Southern Grove-SG-8 - Commercial - Buffer Wall
Landscape Modification
(P24-169)

Planning and Zoning Board - June 3, 2025
Marissa Da Breo-Latchman, Environmental Planner II

Applicant's Request:	To provide enhanced landscaping in lieu of an architectural buffer wall on the western and northern portions of the property per Section 154.12 of the City of Port St. Lucie Code of Ordinances.
Applicant:	Kevin Velinsky, Lucido & Associates
Property Owner:	Banyan SG8, LLC & PEBB SG8 EAT, LLC
Location:	Northwest corner of SW Becker Rd and SW Village Parkway.

Partial Landscape Buffer Plan

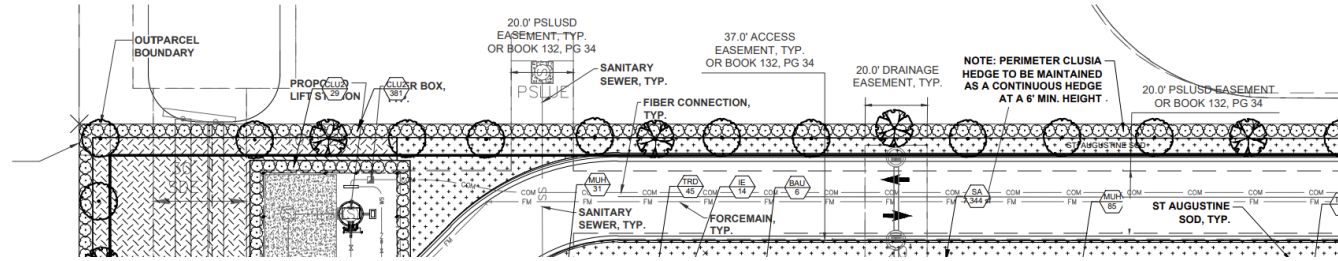
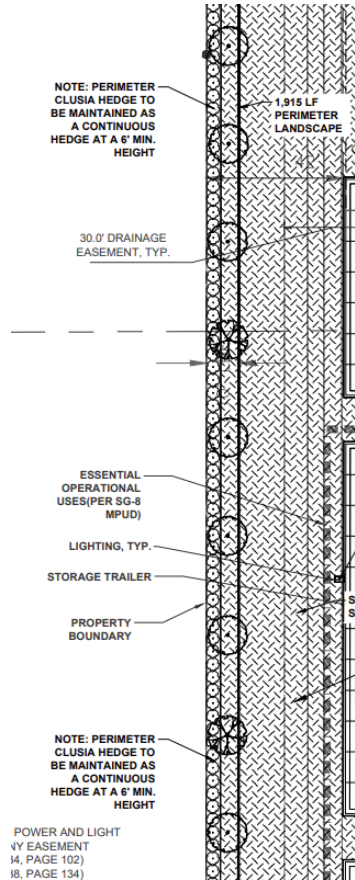
- The applicant is requesting to provide enhanced landscaping in the form of a continuous 6' hedge, assorted canopy trees and open areas in lieu of an architectural wall on the western & northern perimeters of the property.
- Per Section 154.03(C)5 of the Landscape and Land Clearing Code, a wall is required in a landscape buffer strip where commercial, industrial, institutional, office, or public facility uses abut property to the side or rear which is designated with a residential or open space land use.

- **Motion to approve**
- **Motion to approve with condition that the property owner maintain the hedge in the Landscape Buffer at a minimum of 6'.**
